Building Code of Australia

Assessment Report

**Project Address: Gillieston Public School
redevelopment and new public preschool**

Report Number: RE220628

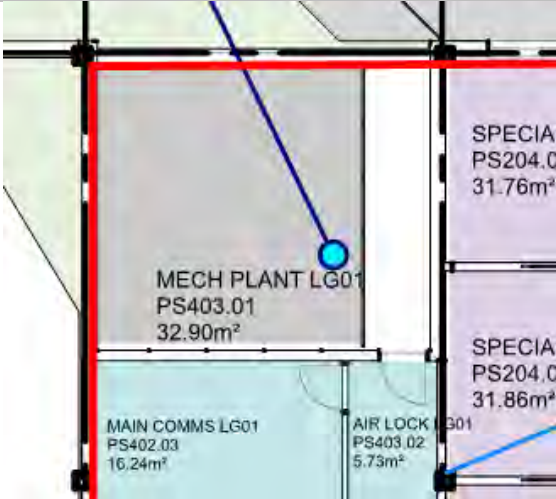
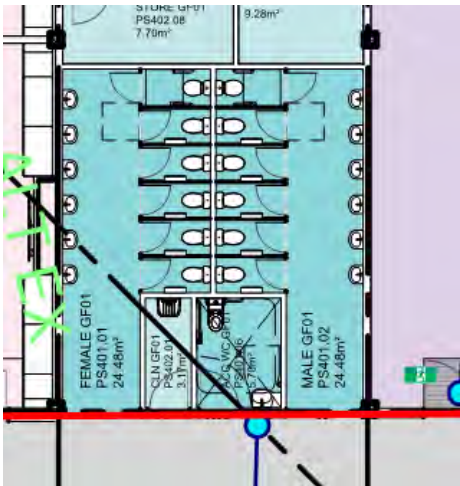
C3D10 Separation of classifications	Building BC has different classifications between Lower Ground (Class 5 and 9b) and Ground (Class 9b). However, these attract the same FRL requirements and therefore will be able to comply with this clause without further separation.	Capable of Complying

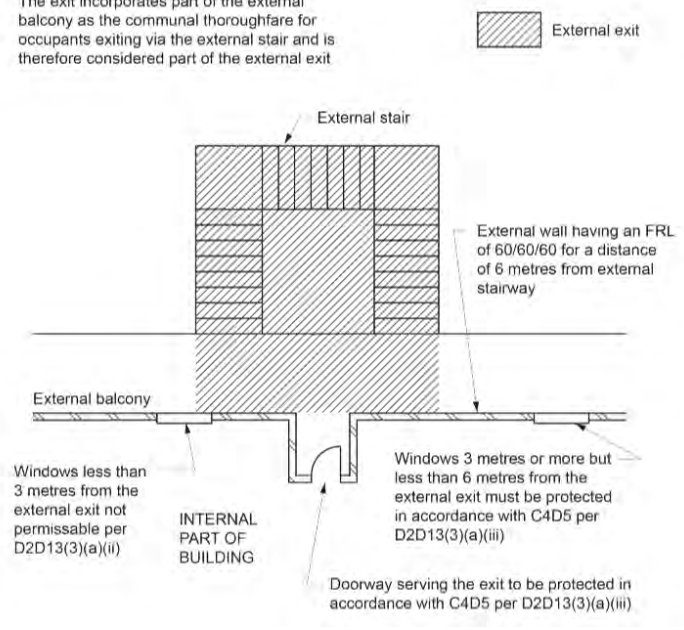
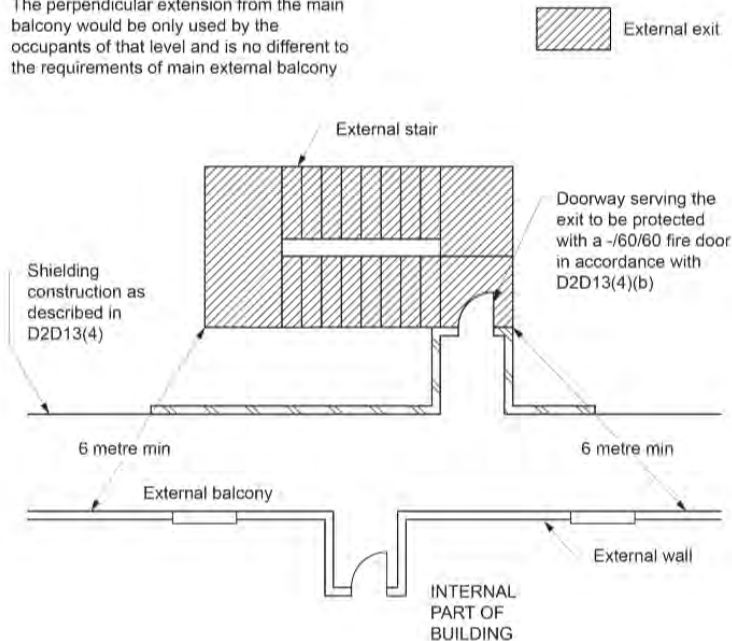
BCA Clause	Assessment and Comment	Status
Part D1 Access and Egress		
NSW D2D3 Number of exits required	Not less than 2 exits are required to any storey in a Class 9b early childhood centre and to each storey in a primary school with a rise in storeys of 2 or more. Otherwise in a Class 9b building any storey that accommodates more than 50 persons is required to have two exits.	Performance Solution

BCA Clause	Assessment and Comment	Status
	 <p><u>Ground Level</u> Building BC: Sanitary provisions only have one exit</p>  <p>Building BC: SLSD office 01 PS 102.06 & staff WC do not have access to 2 exits</p>

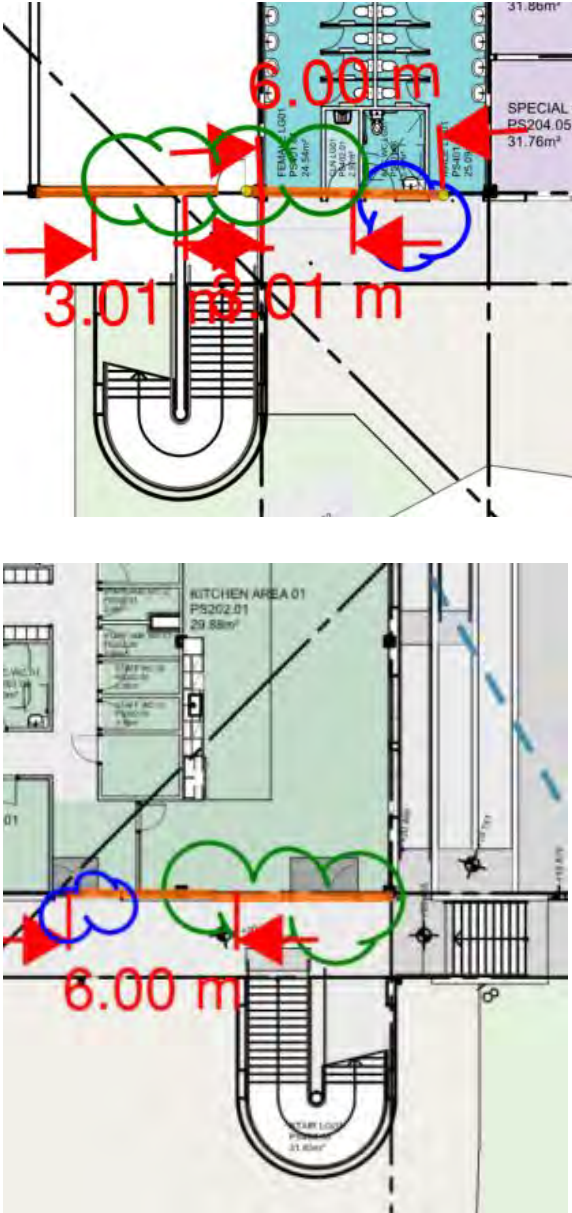
BCA Clause	Assessment and Comment	Status
	<p>Building BC: Mech plant GF 01 is able to comply with the concession of only one exit however Store GF 01 and Comms GF do not have access to two exits.</p> 	
D2D4 When fire isolated exits are required	<p>All stairs serving Building BC directly are required to be fire isolated stairs as they connect or pass through more than 2 storeys of Class 9b use and are not sprinklered to AS 2118.1 throughout (to allow an additional storey over 2):</p> <p>The stairs are configured as external stairs and therefore have been considered under the provisions of D2D13 below as external stairs in lieu of fire-isolated stairs. Further clarification has been provided on the surround to the stairs, being of perforated metal screen, with perforation openings of at least 50% of the screen. The stairs would therefore be considered as external stairs and designed under the provisions of clause D2D13 below.</p>	Note

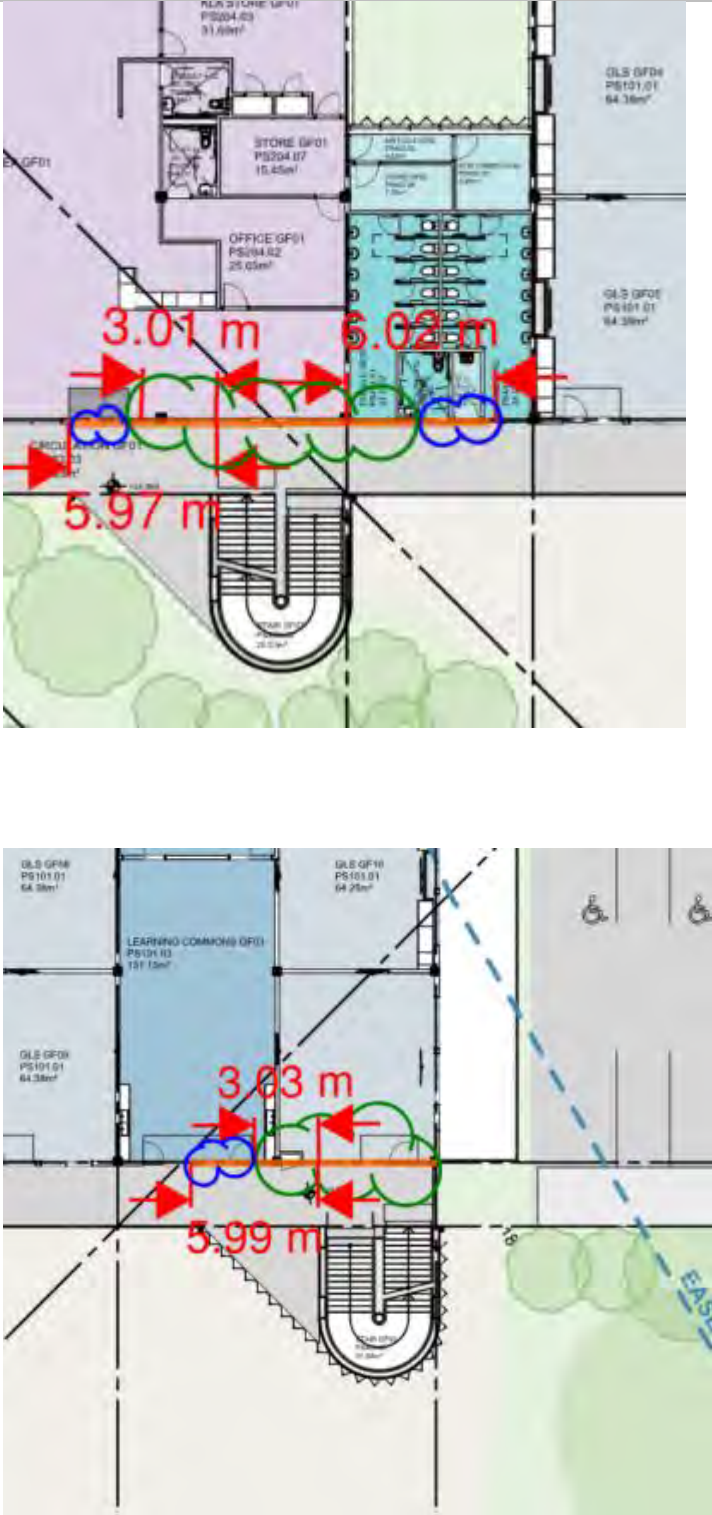
BCA Clause	Assessment and Comment	Status
D2D10 Exit width not to diminish in direction of travel	The unobstructed width of a required exit must not diminish in the direction of travel to a road or open space, except where the width is increased in accordance with D2D8 (1)(b) or D2D9(a)(i).	Capable of Complying
D2D11 Determination and measurement of exits and paths of travel to exits	The required width of stairs and ramps is to be measured in accordance with this clause.	Capable of Complying
D2D12 Travel via fire isolated exits	The stairs to Building BC are required to be fire-isolated however as they are external stairs they have been assessed as external stairs or ramps in lieu of fire-isolated exits.	Note
D2D13 External Stairs or ramps in lieu of Fire-isolated exits	<p>Building BC has external stairs provided in lieu of fire isolated exits. The design of external stairs in lieu of fire-isolated stairs still intended to provide an equivalence of fire isolation. For prescriptive compliance the following design principles are to be followed:</p> <ul style="list-style-type: none"> (1) Stair to be non-combustible throughout and protection within 6m of the external wall of the building it serves. (2) Protection to be provided as follows: <ul style="list-style-type: none"> (a) the part of the external wall of the building to which the wall is exposed must have- <ul style="list-style-type: none"> (i) external wall of the building should have an FRL not less than 60/60/60 (ii) no openings less than 3m from the exit (except a -/60/30 fire door serving the exit in accordance with C4D19(1)) (iii) Openings 3m or more but less than 6m should be protected in accordance with C4D5) and if wall wetting sprinklers are used they should be located internally <p>NCC 2022 guide indicates this protection described in (2)(a) as below:</p>	Performance Solution

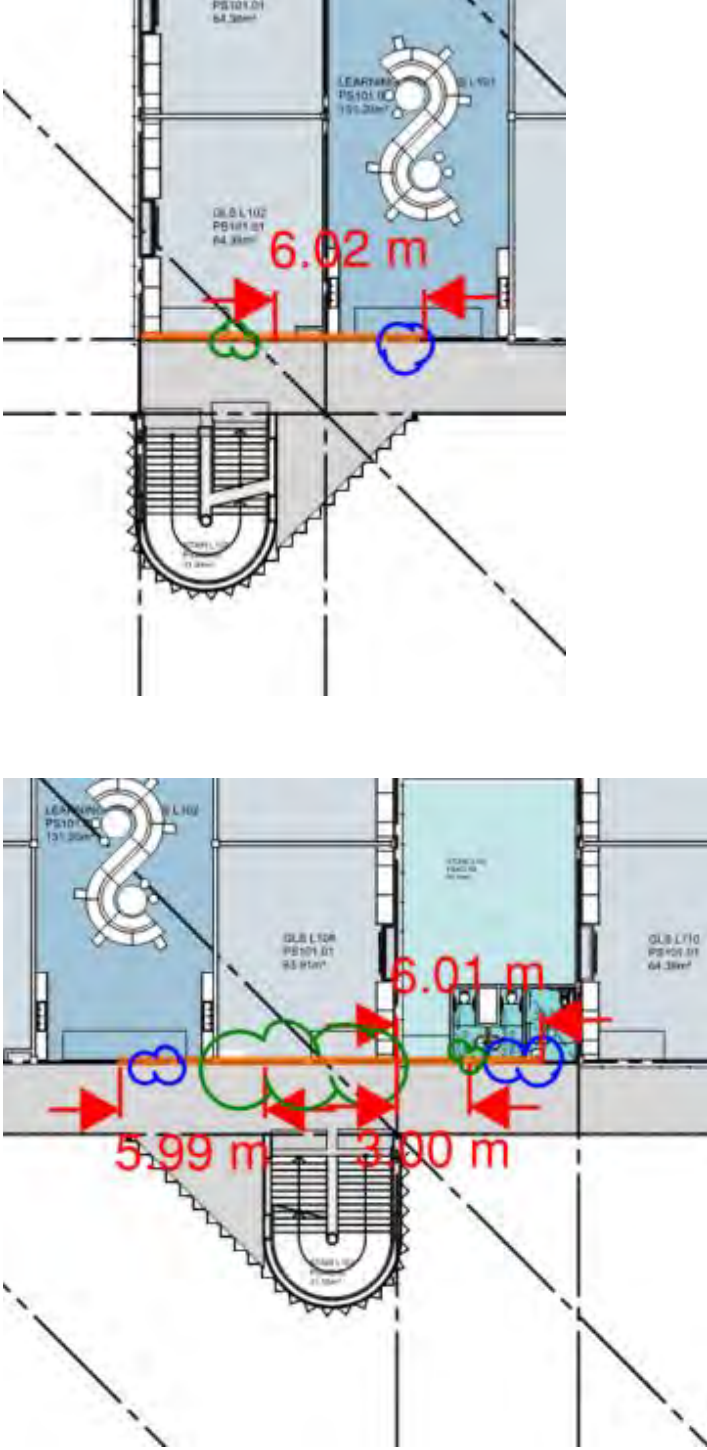
BCA Clause	Assessment and Comment	Status
	<p>The exit incorporates part of the external balcony as the communal thoroughfare for occupants exiting via the external stair and is therefore considered part of the external exit</p>  <p>OR</p> <p>(b) the exit must be protected by construction of a wall, roof, floor or other shielding element from any part of the external wall of the building having an FRL of less than 60/60/60 and any openings in the external wall. The wall, roof, floor or other shielding element must -</p> <ul style="list-style-type: none"> (i) have an FRL of not less than 60/60/60; and (ii) have no openings less than 3m from the external wall of the building ((except a -/60/30 fire door serving the exit in accordance with C4D19(1); and (iii) have any opening 3 or more but less than 6m from any part of the external wall of the building in accordance with C4D5 and wall wetting sprinklers should be located on the side exposed to the external wall <p>NCC 2022 guide indicates this shielding protection described in (2)(b) as below:</p>
